TECHNICAL BULLETIN
Bell Helicopter **TEXTRON**

No. 222-05-173

MODEL AFFECTED: 222 and 222B

SUBJECT: LANDING GEAR ACTUATOR P/N 222-336-001-015, INTRODUCTION OF

Retract Actuator
Figure 1

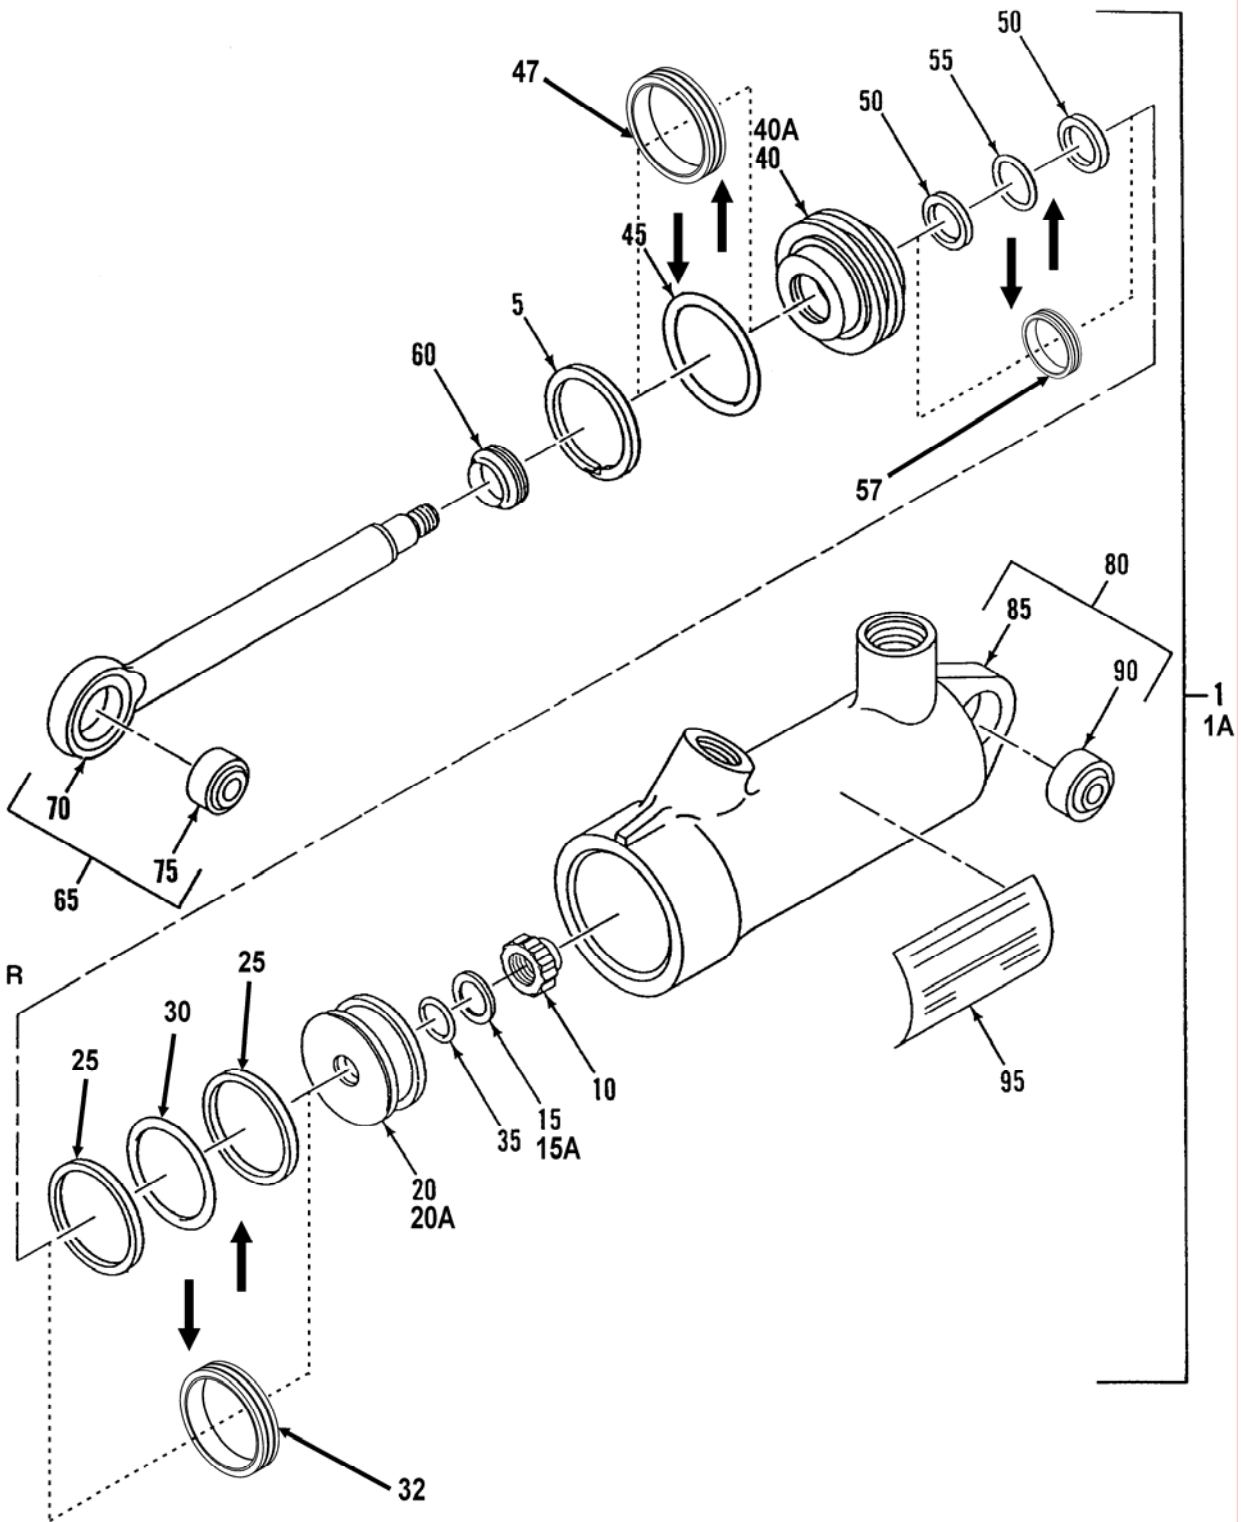
- (4) For OMP3974-1, remove washer (15) and piston head (20).
- (5) For OMP3974-3, remove washers (15A, qty 3) and piston head (20A).
- (6) For OMP3974-1, remove and discard the two packing backup retainers (25), packing (30), and packing (35) from the piston head (20).

- (7) For OMP3974-3, remove and discard AGT ring seal (32) and packing (35) from the piston head (20A).
- (8) Remove the gland (40 or 40A) from the piston rod assembly (65).

- (9) For OMP3974-1, remove and discard the packing (45), two packing backup retainers (50), and packing (55) from the gland (40).
- (10) For OMP3974-3, remove and discard AGT ring seals (47 and 57) from the gland (40A).

OMP3974-1 (Discard these items)	OMP3974-3 (Replace with these items)
Washer (15) Piston Head (20) Packing, Backups (25) (Qty of 2) Packing (30) Gland (40) Packing (45) Packing, Backups (50) (Qty of 2) Packing (55)	Washers (15A) (Qty of 3) Piston Head (20A) AGT Ring Seal (32) Gland (40A) AGT Ring Seal (47) AGT Ring Seal (57)

- (3) For OMP3974-3, install new scraper (60), and install new AGT ring seals (47 and 57) on the gland (40A).
- (4) Carefully move the gland (40 or 40A) onto the piston rod assembly (65).

- (5) For OMP3974-1, install a new packing (35), two new packing backup retainers (25), and new packing (30) on the piston head (20).
- (6) For OMP3974-3, install new packing (35), and install new AGT ring seal (32) on the piston head (20A).

- (7) Carefully move the piston head (20 or 20A) onto the piston rod assembly (65).
- (8) Install the washer (15 for OMP3974-1 or 15A (qty of 3) for OMP3974-3) and self-locking nut (10) on the piston rod assembly (65). Then tighten the self-locking nut (10) to 100-140 pound-inches (11.3-15.8 N•m) for OMP3974-1 and 150-180 pound-inches (16.9-20.3 N•m) for OMP3974-3.
